STATE OF NORTH CAROLINA
DEPARTMENT OF TRANSPORTATION

August 14, 2008

Subject: **Application for Modification to Individual Permit** for NC 16 from north of SR 1386 in Lincoln County to North of SR 1895 in Catawba County. Federal Aid Project No. STP-F-24-1(34) State Project No. 8.1830501. **TIP Project No. R-2206B/C.** \$570.00 Debit from WBS Element No. 34383.1.5.

MATCHLINE -L- STA. 266+38

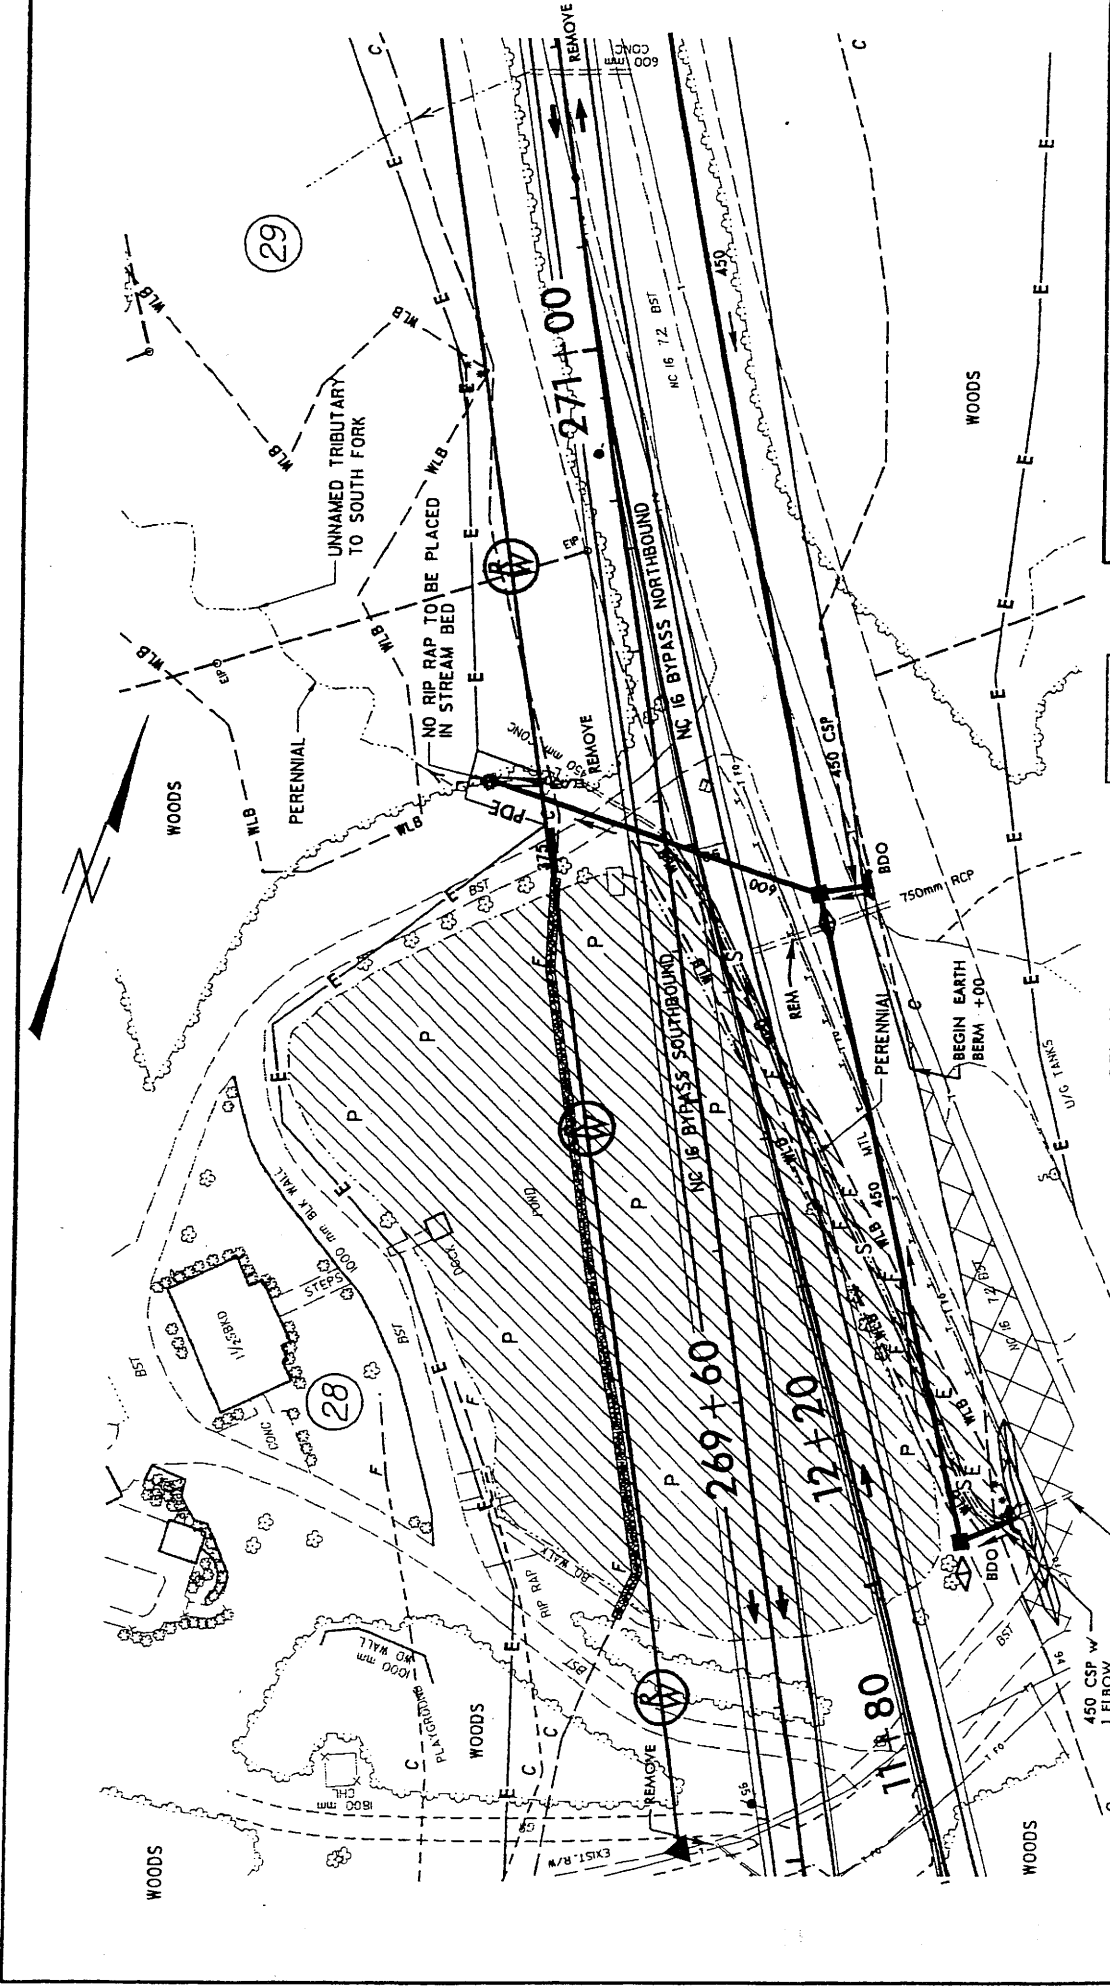
Permit Site 16C, Station 270+32-L

To incorporate a drainage system revision, a 30-inch (750mm) reinforced concrete pipe (RCP) will be installed in place of the 24-inch (600mm) RCP originally permitted (Mod Sheets 4 & 5 of 5). There are no additional temporary or permanent impacts associated with this change in pipe size.
